RFT 26-083 Interior Renovations & Air Conditioner Upgrades at Frontenac PS

The following, issued by the Halton District School Board (HDSB) June 18, 2026, shall be incorporated in the specifications and shall form part of the proposal document for the above.

TENDER ADDENDUM NO. 1
2026.06.17

Interior Renovations and Air Conditioner Upgrades at Frontenac Public School
Halton District School Board RFT 26-083
5140 Pinedale Avenue, Burlington, Ontario

NOTE: ALL SCOPE IN STAFF ROOM 120 AND FOOD ROOM 121 TO BE COVERED UNDER SEPARATE PRICE AS IDENTIFIED IN BID FORM

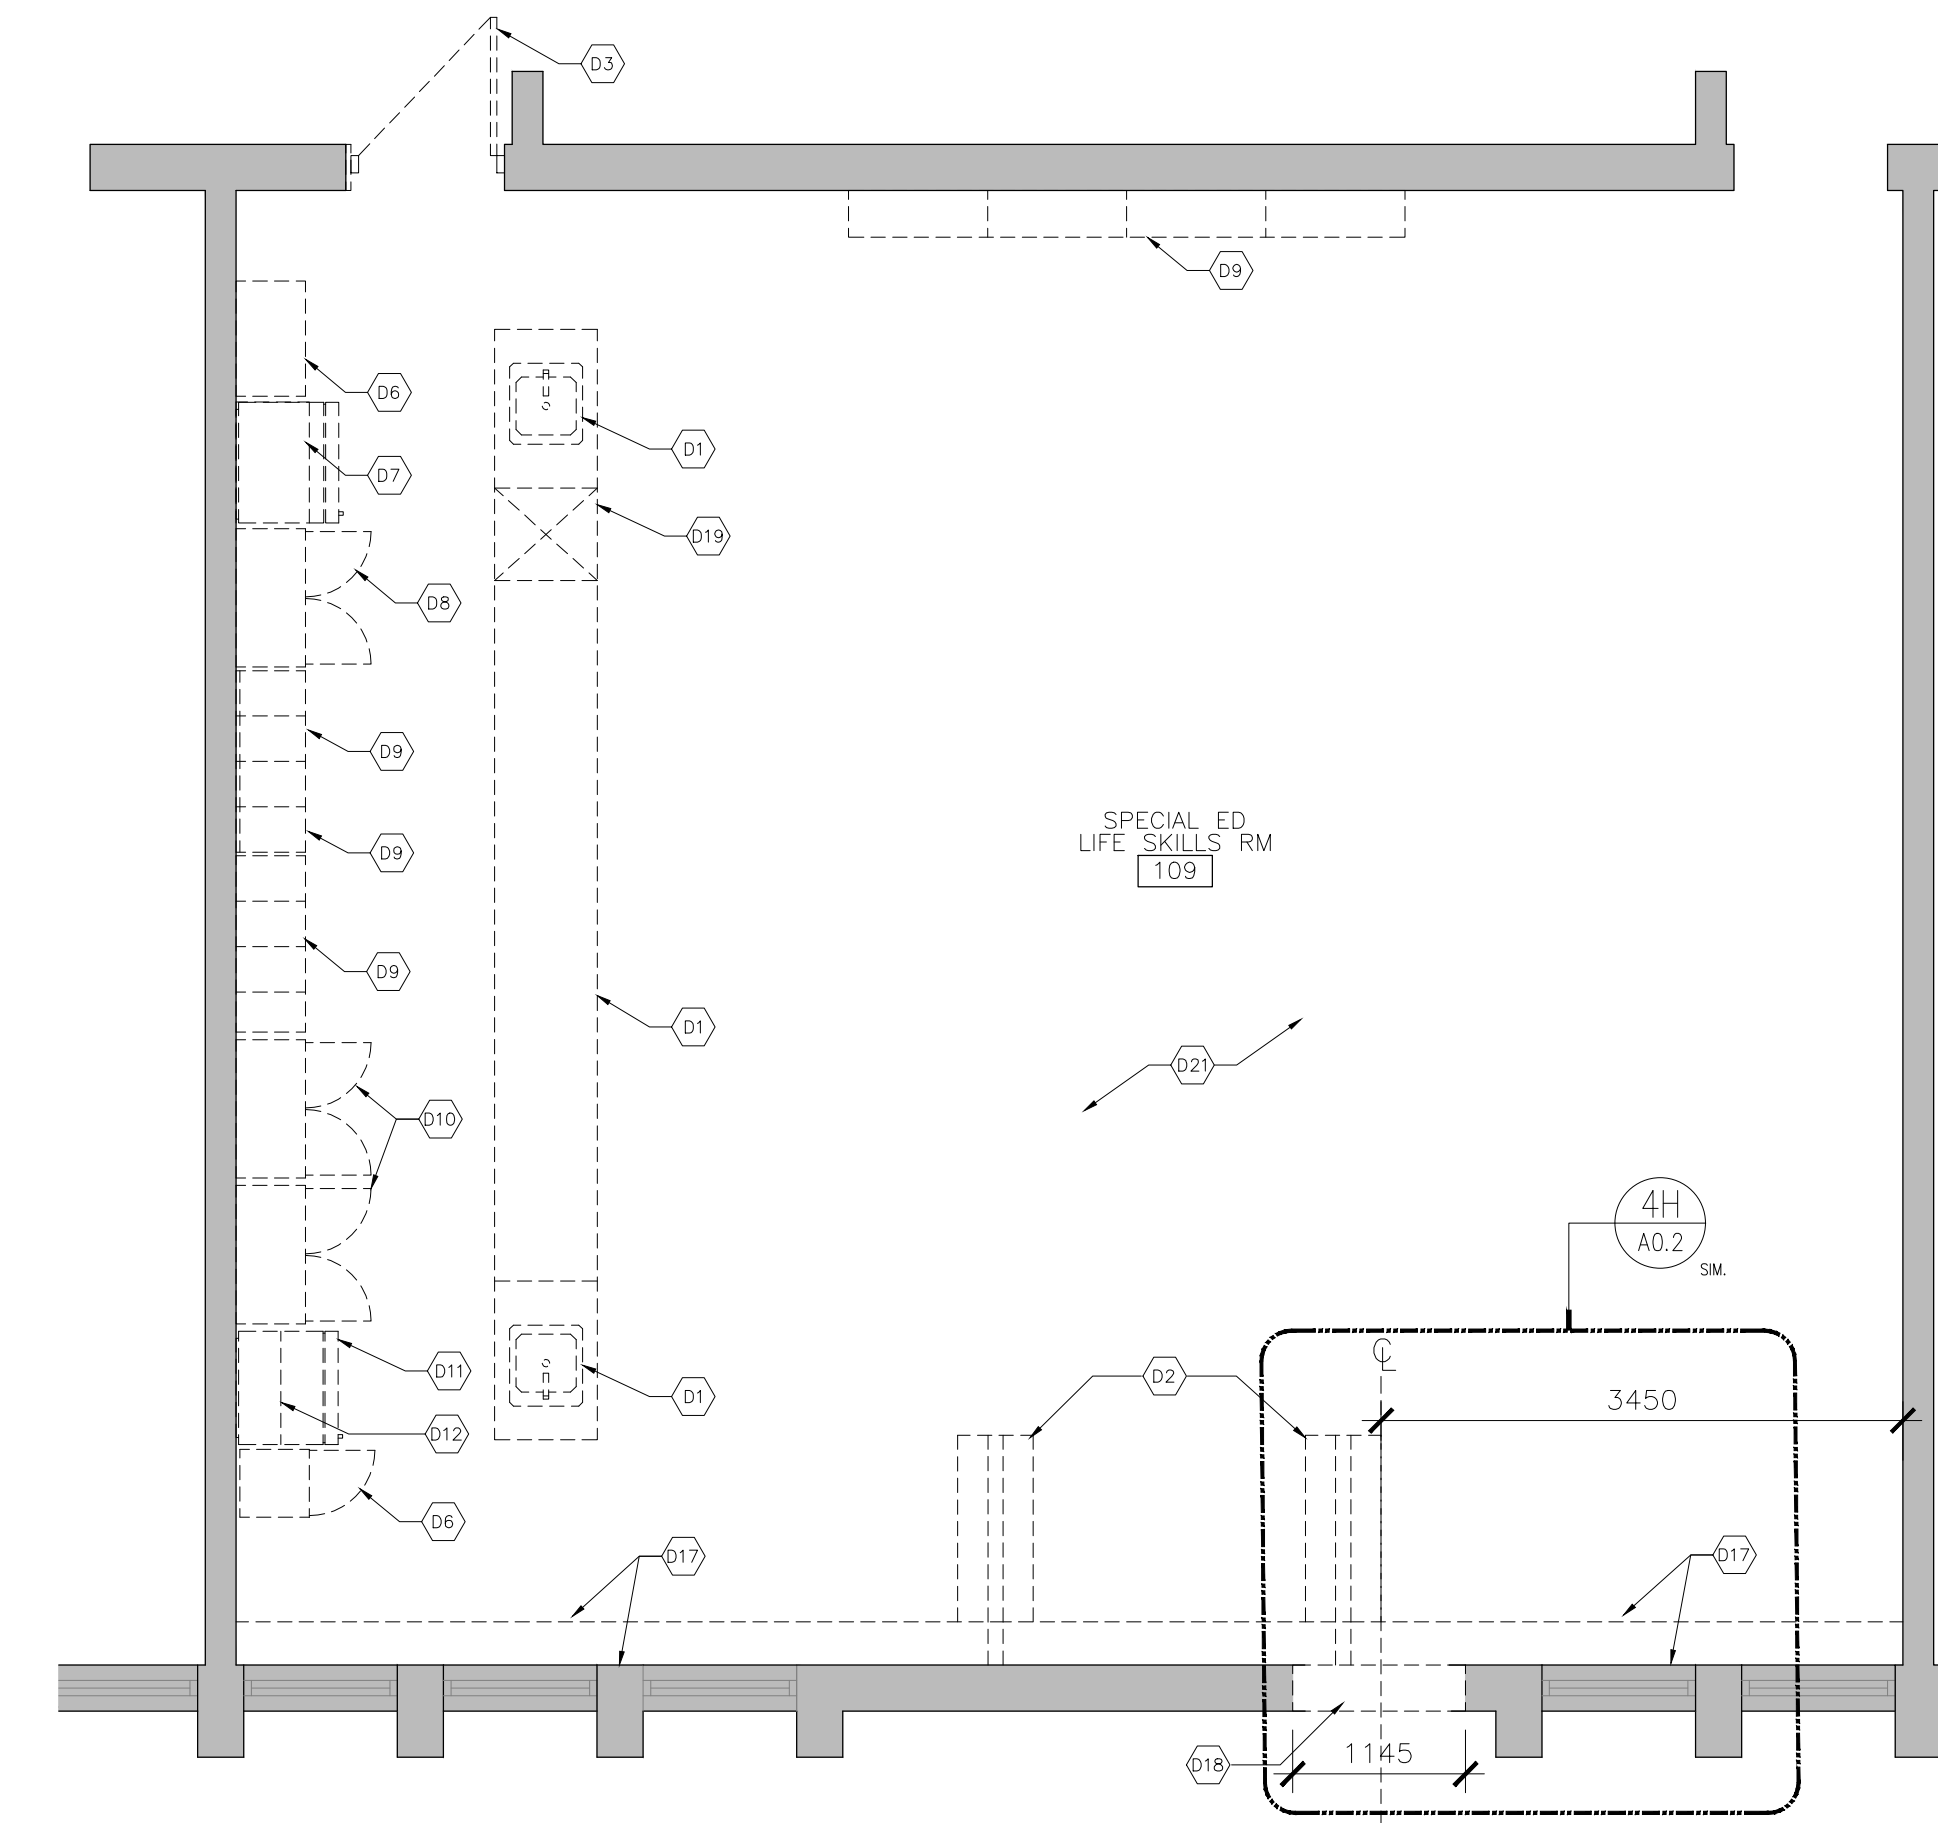
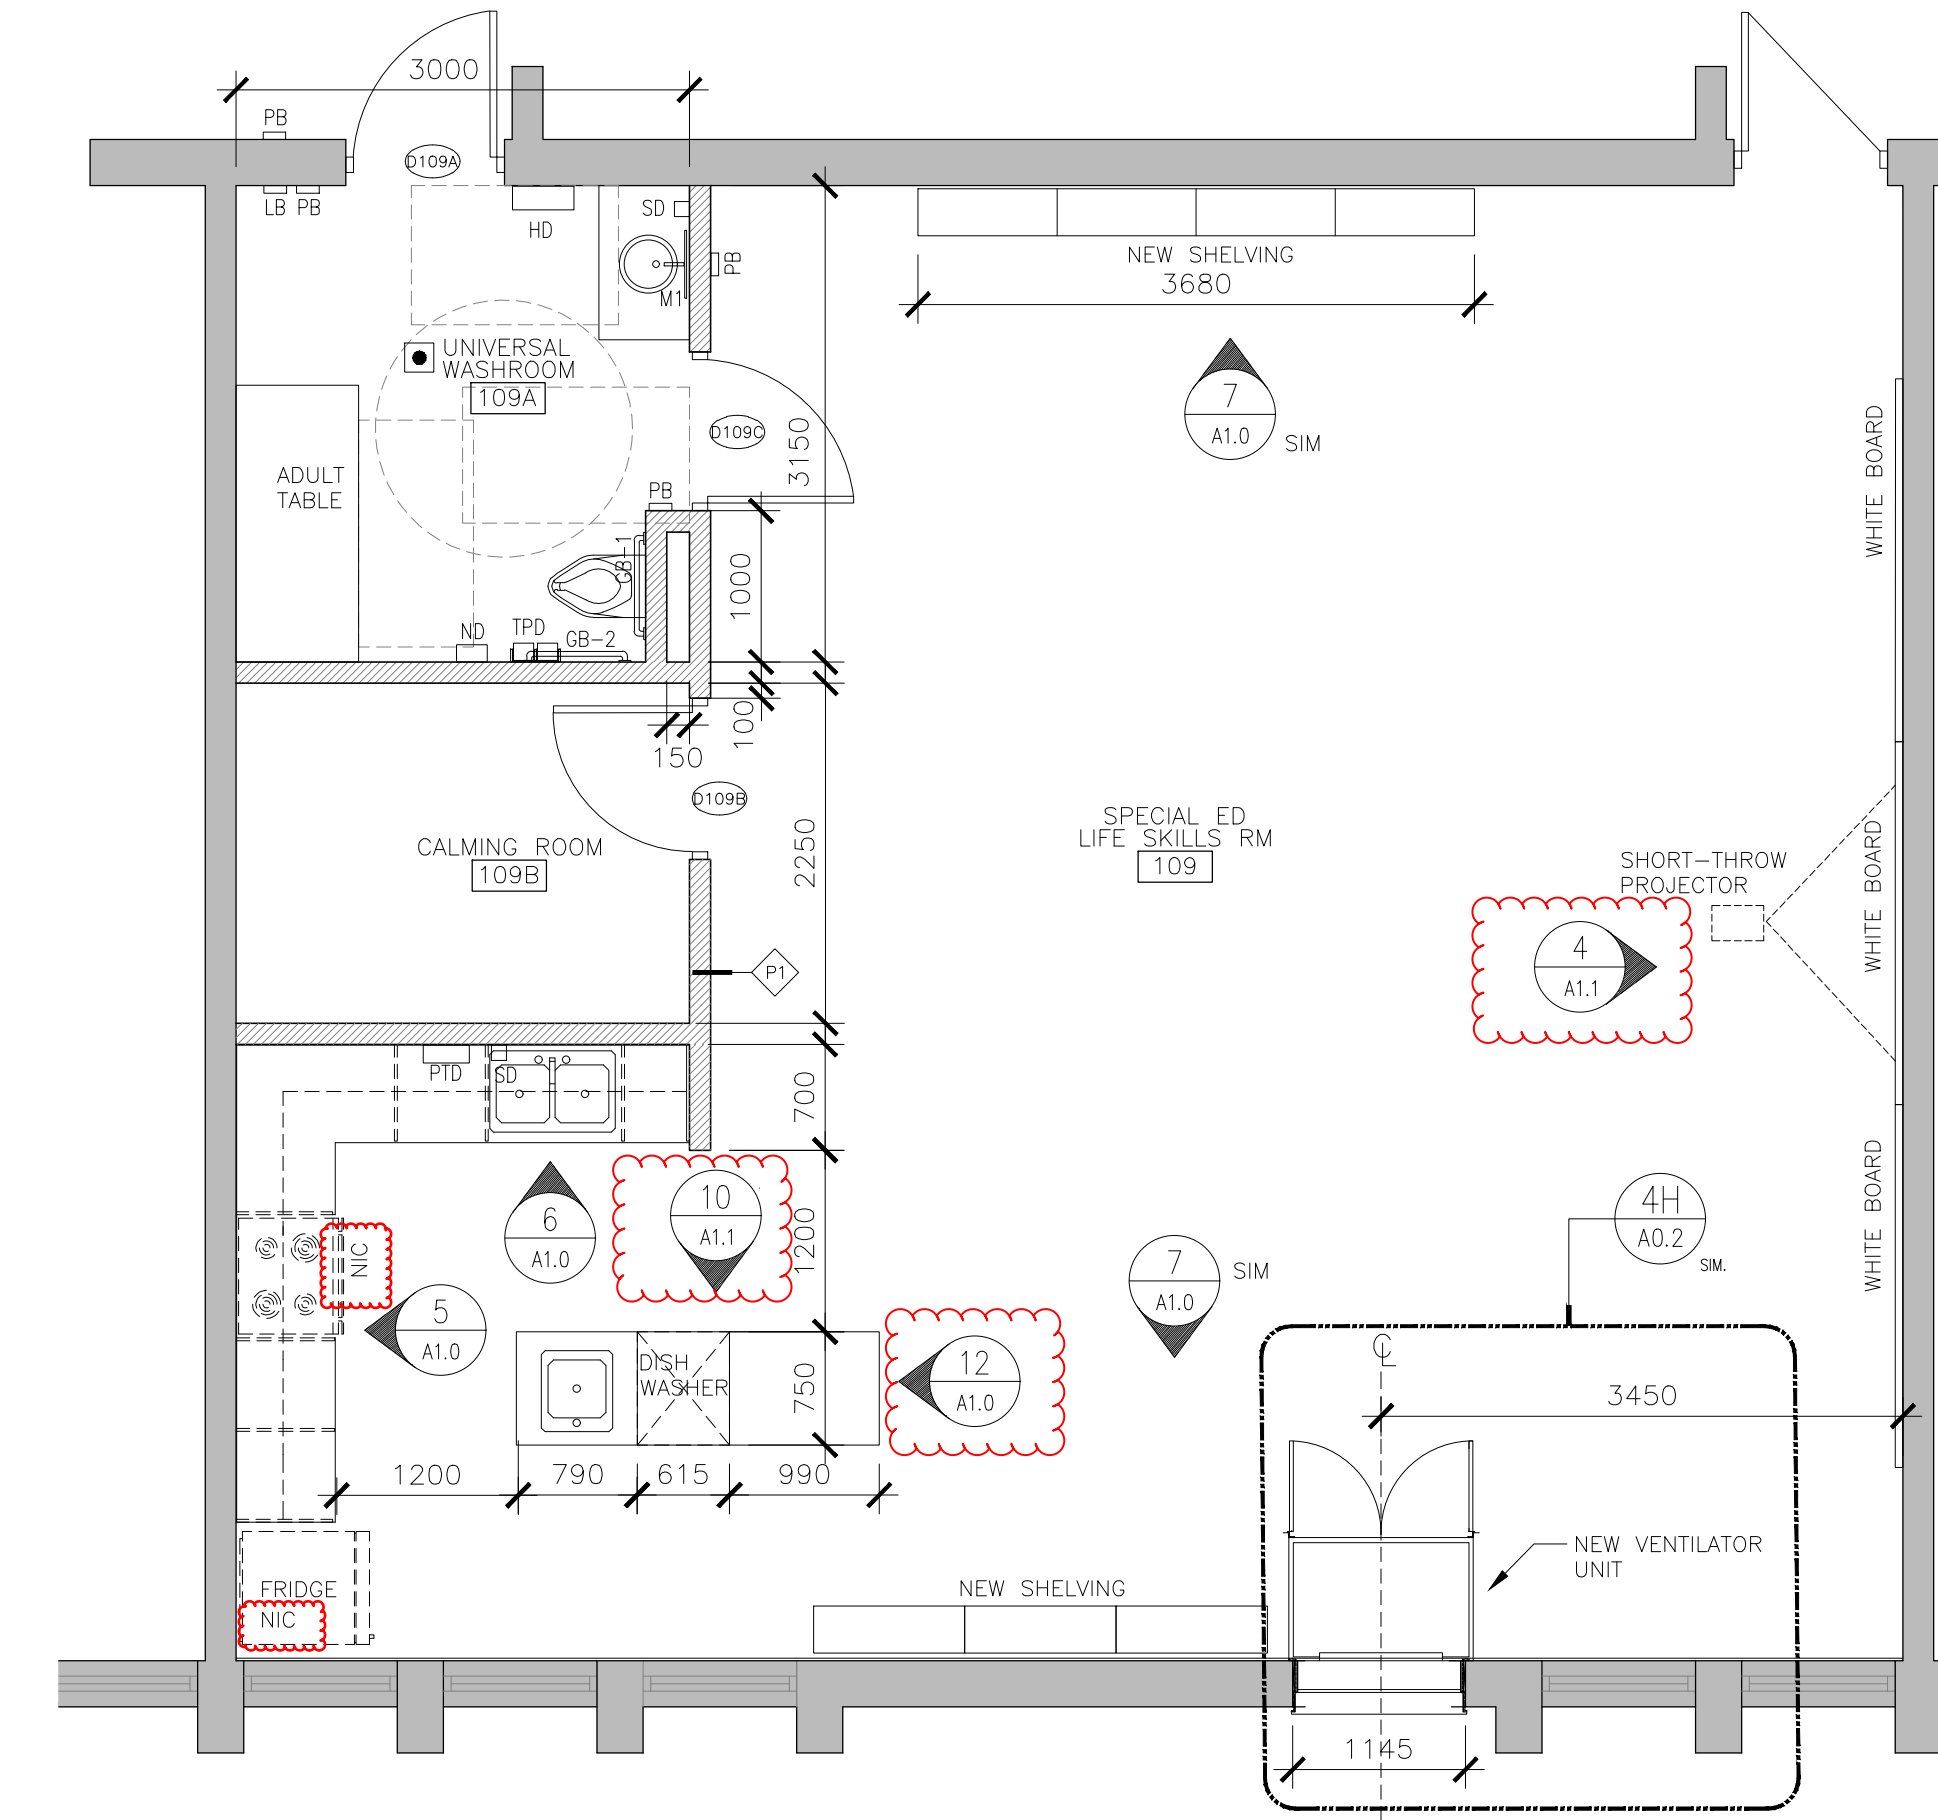
1.2: Drawings 2/A1.0, 4/A1.0, 5/A1.0 and 6/A1.0 Proposed Plans and Interior Elevations:

1. ADD reference bubbles to detail millwork sections. See attached revised drawing A1.0 with bubbled revisions.
